# Rezoning Transportation Analysis

Petition Number: 2025-073

Date	Description
07-24-25	First Review (CM)
08-20-25	Second Review (DR/CM)

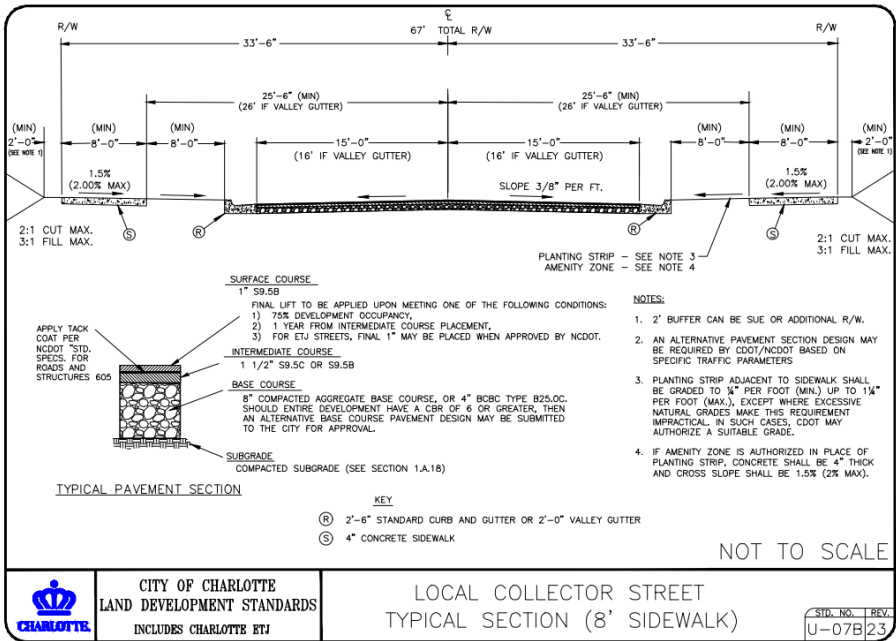
### 1. Curblines:

a. ~~South Tryon Street: Location of future curb and gutter is 34.5'.~~

~~4+ Avenue, Buffered/Separated Bike Lanes~~

~~Label and dimension the curb and gutter from the centerline for each road on the site plan.~~

b. ~~West Bland Street: Location of future curb and gutter is 17.5'.~~

~~Label and dimension the curb and gutter from the centerline for each road on the site plan.~~
